Addendum Number 3, September 13, 2023

RE: Mobile Civic Center Parking Facility
Mobile, Alabama
C-085-22

FROM: Evan Terry Associates, LLC
One Perimeter Park South, Suite 200S
Birmingham, Alabama 35243

OVERALL SITE UTILITY PLAN

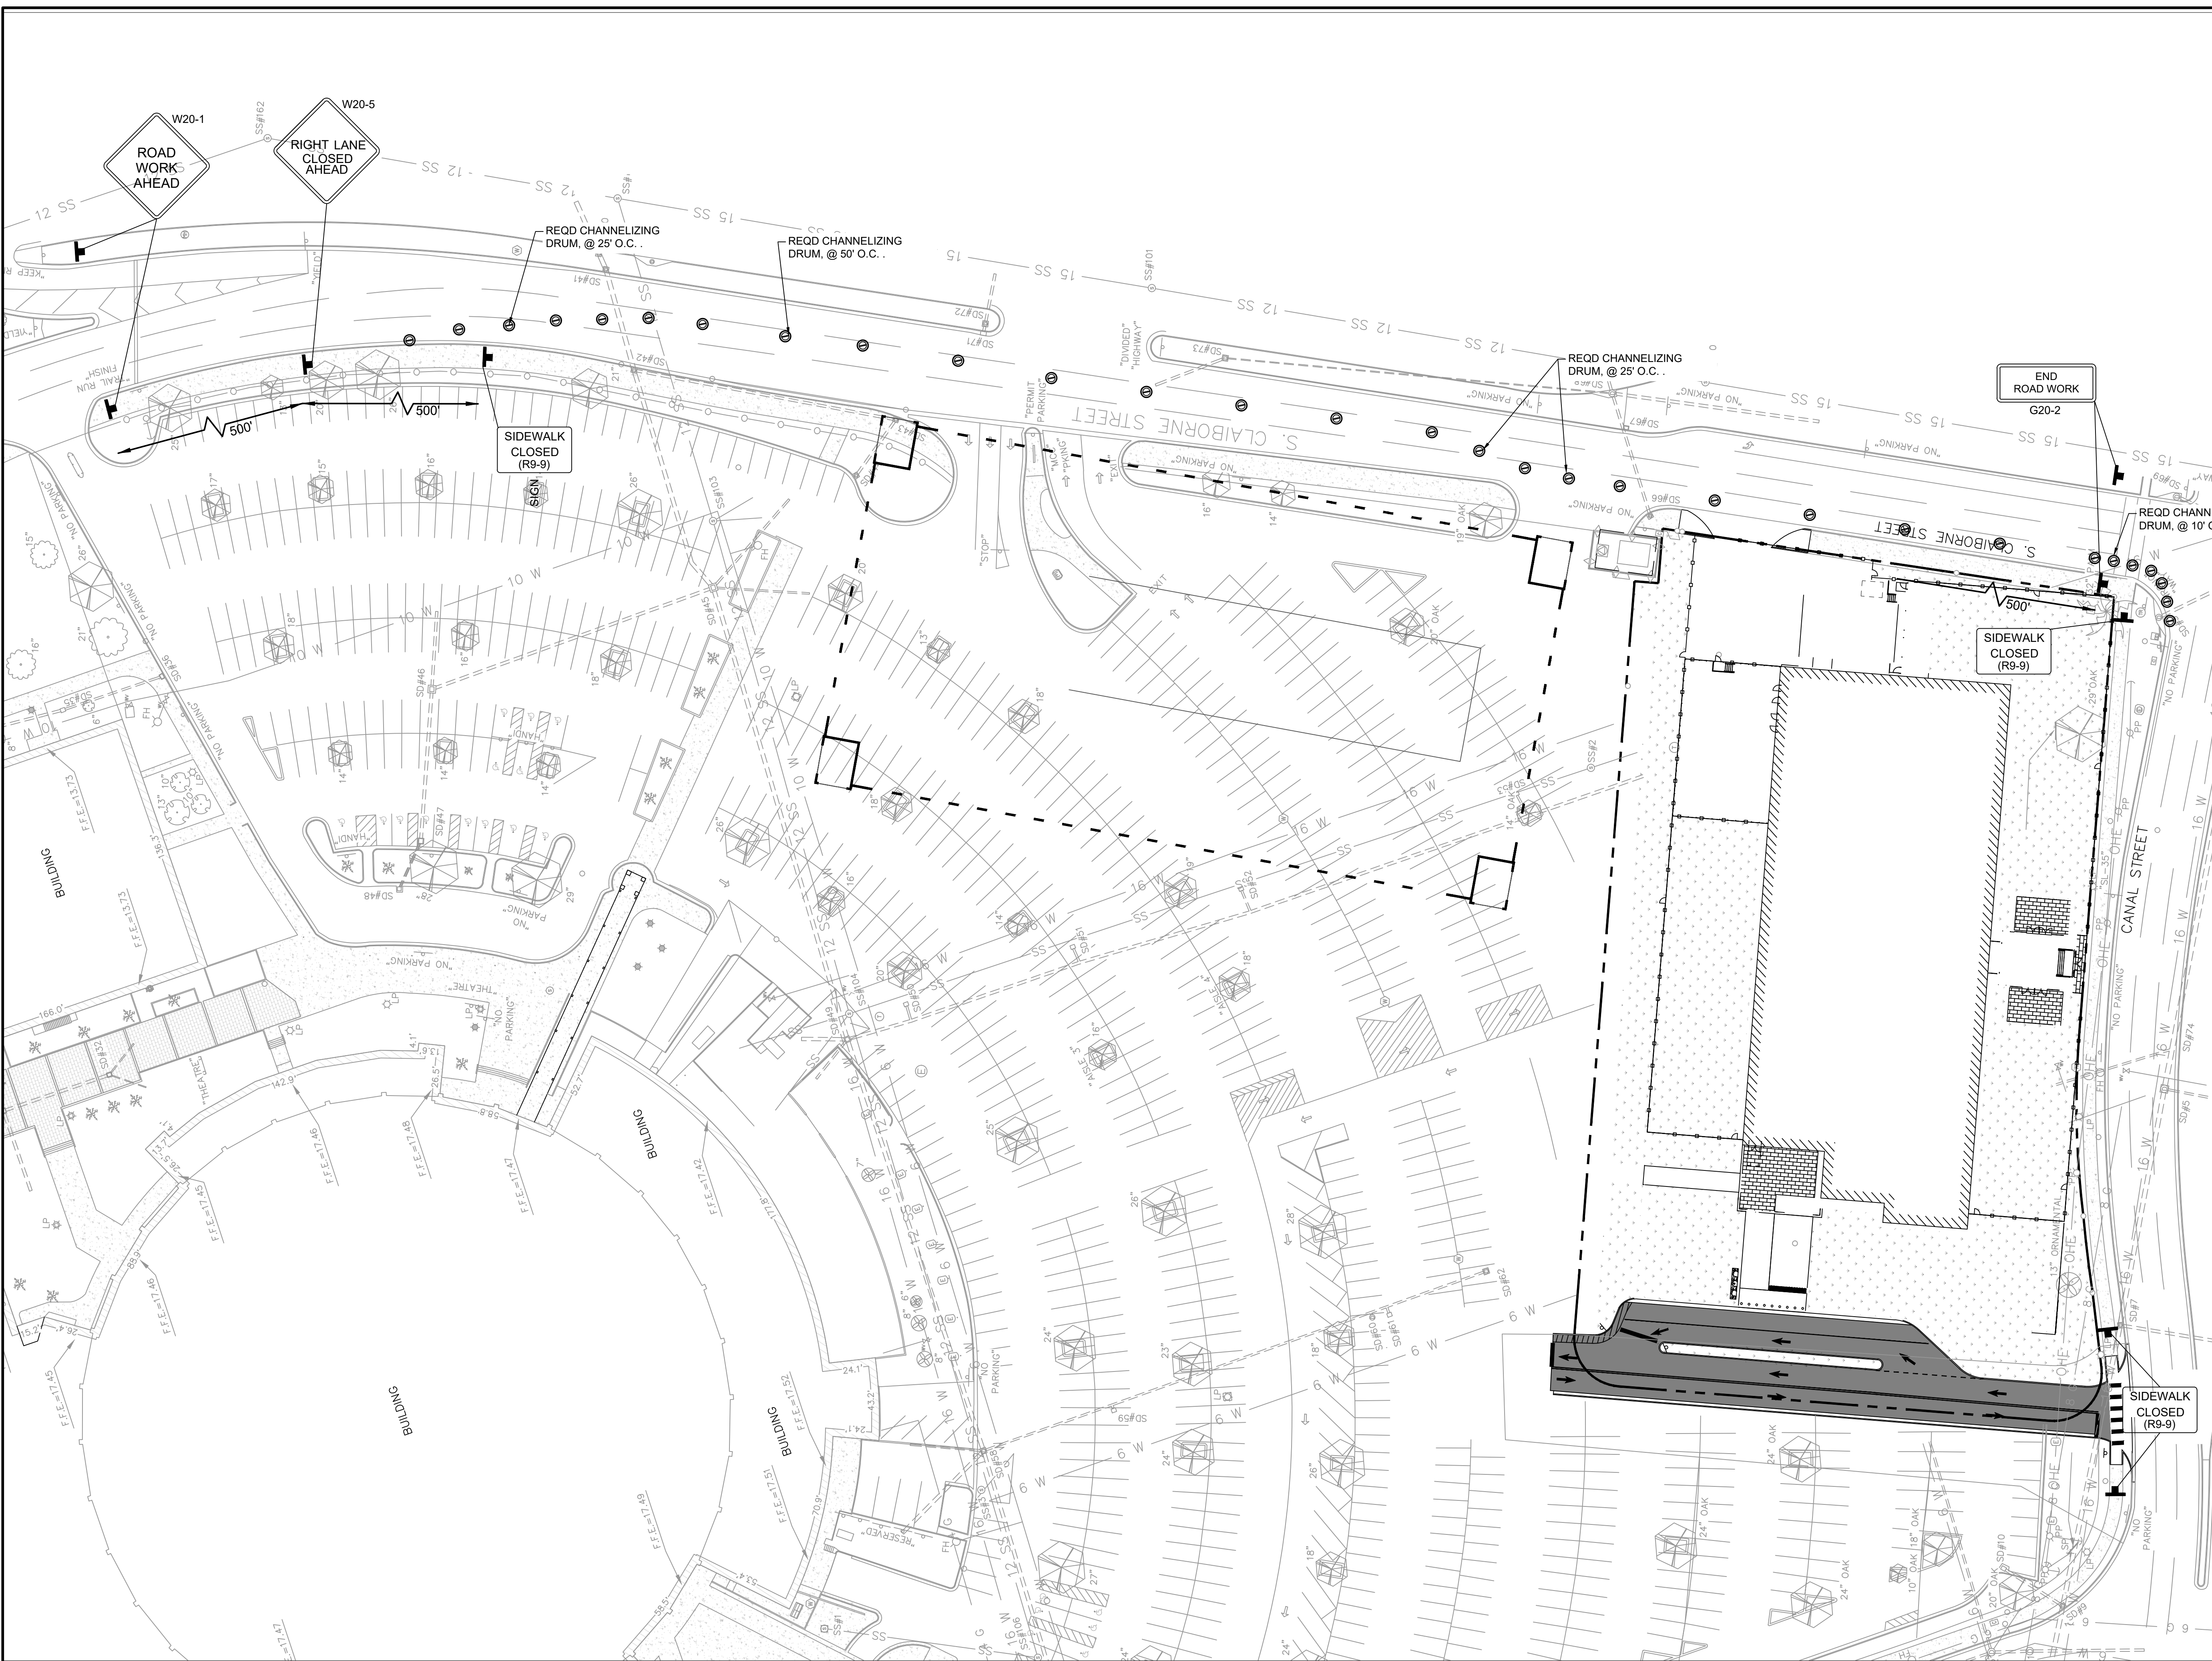
ITEM 12 Is there a master traffic control plan available for review as it appears the sidewalk and watermain work along S Claiborne Street will continue beyond our site.

ITEM 54 Other than the limits of construction noted on the civil plans, is there any other space on site that can be used for contractors offices, laydown, storage, etc.

ITEM 55 Please provide an overall layout of Civic Center property indicating limits of construction and laydown for the Corp of Engineers Office Building to determine adjacencies and potential conflicts for access to site.

RESPONSE **Drawing C6.0 (Overall Site Utility Plan) and C7.1 (Traffic Control Plan) from the USACE waterline installation plan set is attached. These plans are for information purposes only and do not form a part of this contract.**

RESPONSE City of Mobile intends to provide additional area outside the shown limits of construction. Drawing C6.0 (Overall Site Utility Plan) from the USACE waterline installation plan set is attached. This drawing indicates the approximate additional area that may be made available for this contract and the USACE contractor. Any additional laydown area utilized by the contractor shall be fenced in the same manner as the construction site. These plans are for information purposes only and do not form a part of this contract.

RESPONSE See attached drawing C6.0 (Overall Site Utility Plan) from the USACE waterline installation plan set. These plans are for information purposes only and do not form a part of this contract.
